**OUTFLOW VALVE 10HL**

MODIFICATION No.: 23128K2932 ATA SYSTEM: 21

T I T L E : AIR CONDITIONING - PRESSURE CONTROL AND MONITORING - PROVIDE LIGHT-

3 DATE : Oct 08/92 SERVICE BULLETIN No. : A320-21-1056

Location of Bonding Connection for Outflow Valve 10HL Figure 1

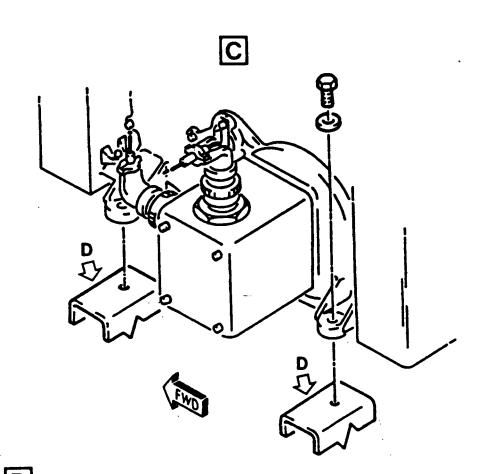
This Service Bulletin introduces two additional bonding connections between the actuating mechanism and the aircraft structure.

Refer to Figure 1

- (a) Remove the outflow valve 10HL in accordance with the AMM 21-31-51, P. Block 401.
- (b) Blank the surface in for the bonding connection in accordance with AMM 20-28-00, P. Block 201 and to dimension as given in figure.
